# United States Department of the Interior

BUREAU OF LAND MANAGEMENT  
Green River District  
Price Field Office  
125 South 600 West  
Price, UT 84501  
<http://www.blm.gov/>

**Re: Resource Recovery and Protection Plan Minor Modification, Further Revision of 3 Right 4 East Longwall Panel, SUFCO Mine**

3R4E REVISED PANEL LAYOUT

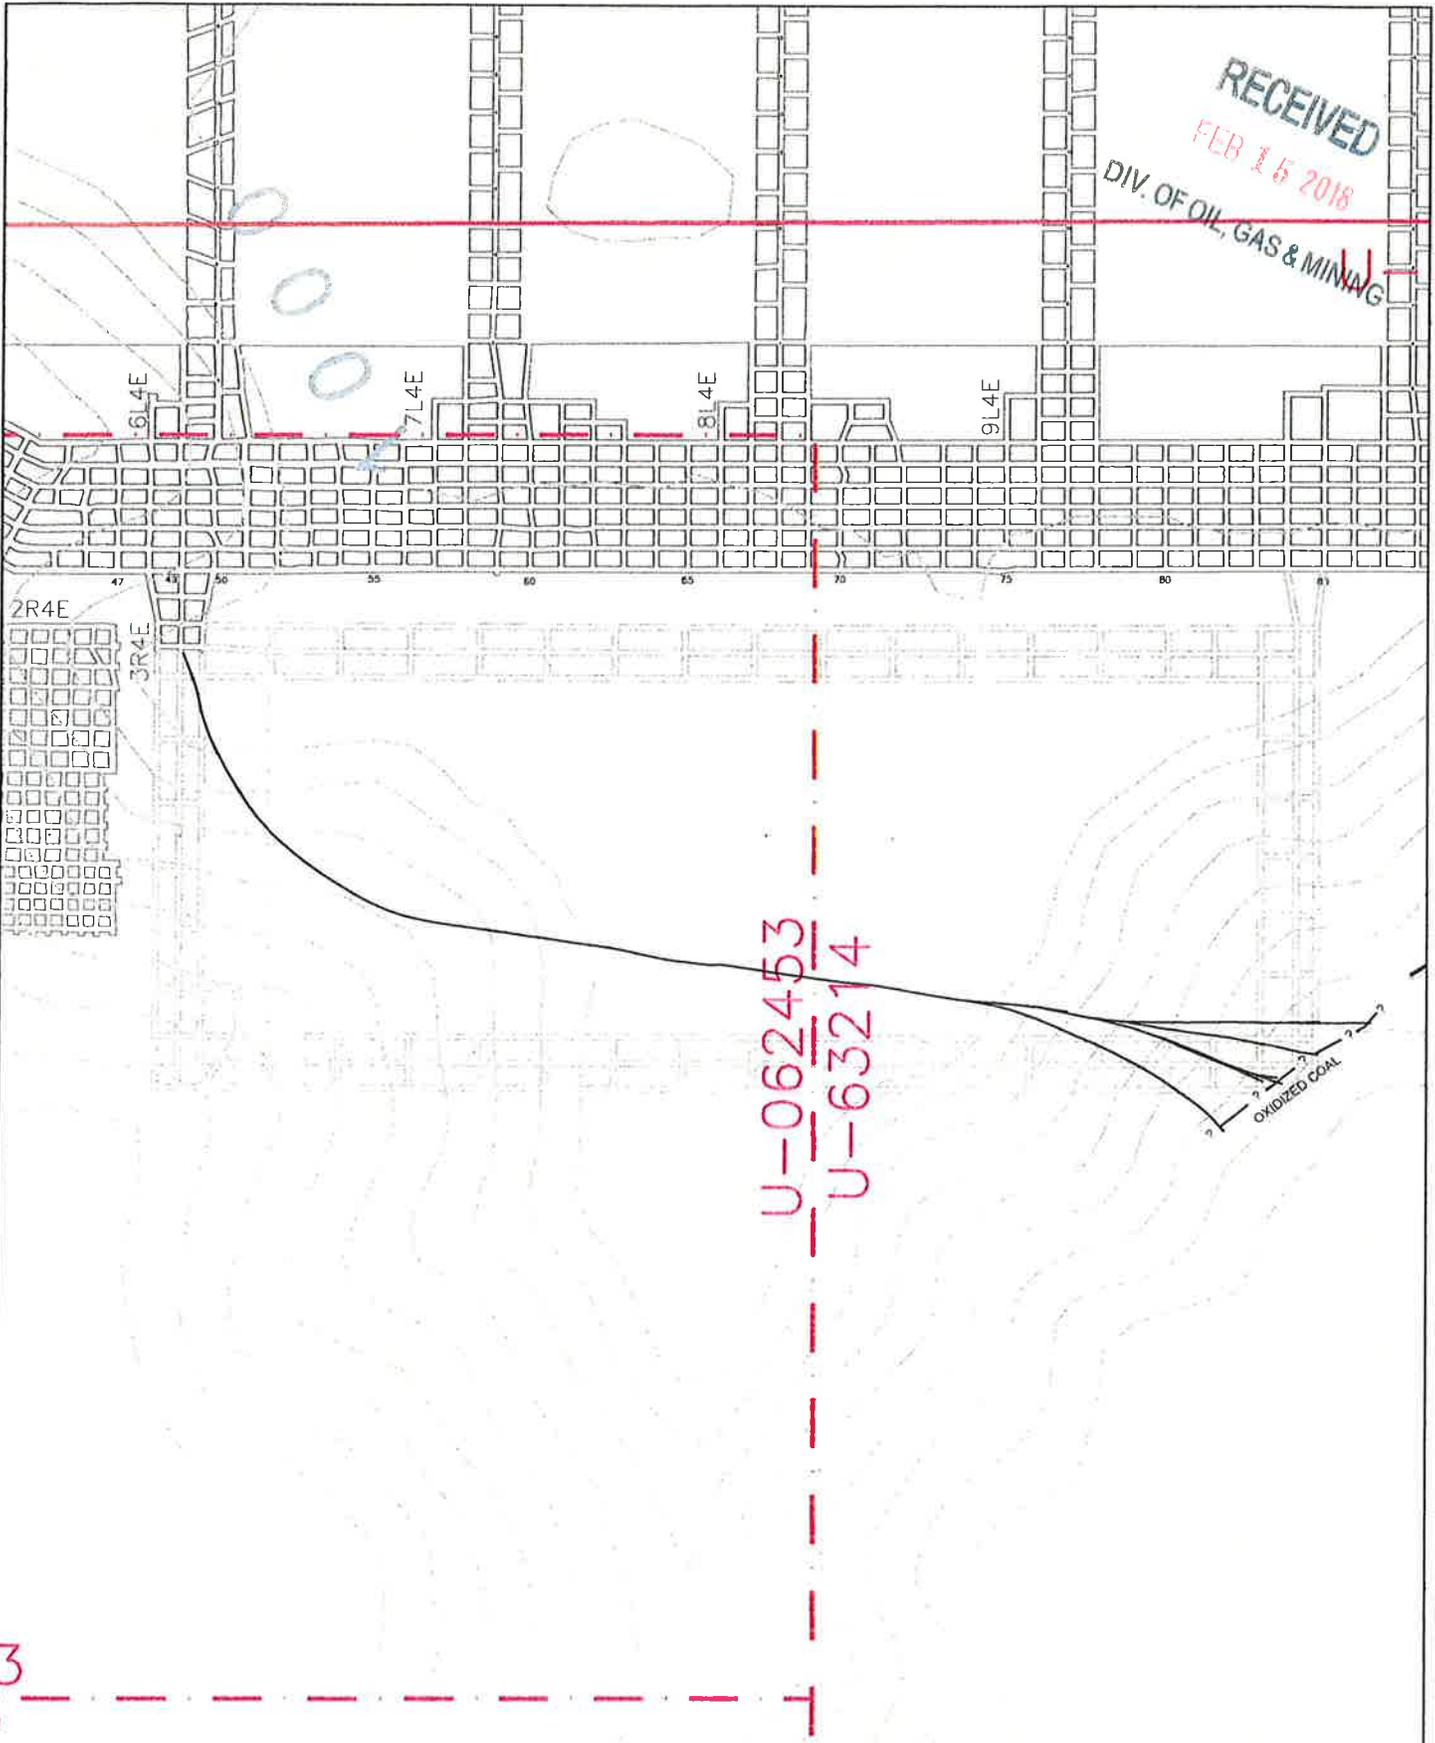
Forest Service and permit approval from Utah Division of Oil, Gas and Mining have also been given. While awaiting these approvals, Canyon Fuel completed in-mine directional exploratory drilling in the proposed panel and encountered oxidized coal in the southeast corner of this panel near the coal outcrop to Quitcupah Canyon. To avoid this oxidized coal area, Canyon Fuel proposes to angle the development entries away from this southeast oxidized coal area and reverse the longwall extraction to west to east. This keeps the longwall set up room and bleeder entries away from the oxidized coal area and minimizes the longwall area that must be cut off to avoid this area.

**Approval:** This letter authorizes Canyon Fuel to adjust the previously approved plan for the development and mining of 3R4E longwall panel as shown on the enclosed approved mine map. This approval is subject to all requirements and plans from the Mine Health and Safety Administration (MSHA). As part of this approval, please submit within 60 days drilling data from the in-mine exploratory drilling that shows the oxidized coal area for our file records.

**Analysis & Maximum Economic Recovery (MER) Determination:** The BLM agrees with the proposal as a logical layout plan for this longwall panel with the encountered oxidized coal in the southeast corner. As this oxidized coal area cut off the southeast corner of the originally planned longwall panel, the proposed layout will avoid this area and thus will achieve MER of the Federal coal.
